Additional/Revised Material Submittal Form

Permit (File) Number: DSRFY 2024-002 Design Professional in Charge: Barbara A. Beier

Project Name: 34th St. Townhouses New Addressing: 211, 219, 227, and 235 w. 34th St.

Project Address: 205 and 209 W. 34th St. **Garden City, Idaho, 83714**

Elevations

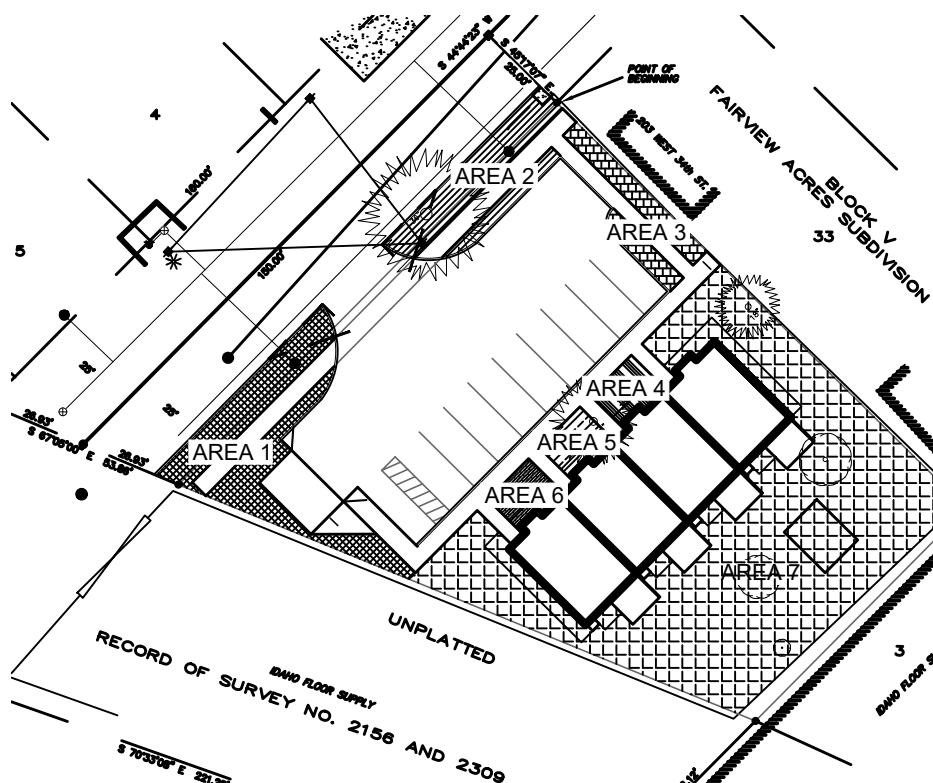
1. A-2 Site Plan - See noted Revisions in the Title Block
2. L1.0 Landscape Plan per RE + P Landscape Firm
3. A-7 elevations - See noted Revisions in the Title Block
4. Vicinity Map
5. Photos of rendering of front Elevation, Canopy above the Front Dr., Shed Canopy above Back Door, 34th St. Photo
6. Arborist Report
7. Schematic of 34th St.

△ Exterior Materials Colors
△ Shed Canopy above Door
